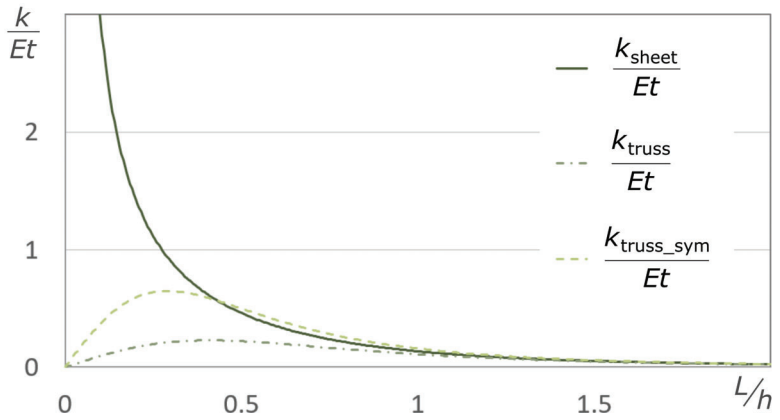
Page	Place	Error	It should be
122	first line below phase angle	reference to equation 10.14	should be to equation 10.15
168	thickness in figure of thin tube	$t = q$	$t = \frac{q}{2}$
170, 171	equations 13.12, 13.13, 13.15	θ could have been expressed in L and h	$k_{\text{truss}} = \frac{Eh^3Lt}{4L^4 + 4L^2h^2 + h^4}$
171	equations 13.14, 13.16	ht^3	h^3t
171	above figure 13.27	height to length ratio h/L	length to height ratio L/h
171	last sentence	stiffness almost the same as the stiffness of the sheet	that is not the case, it is not almost the same
172	figure 13.28	stiffness of symmetrical truss should be as in figure:
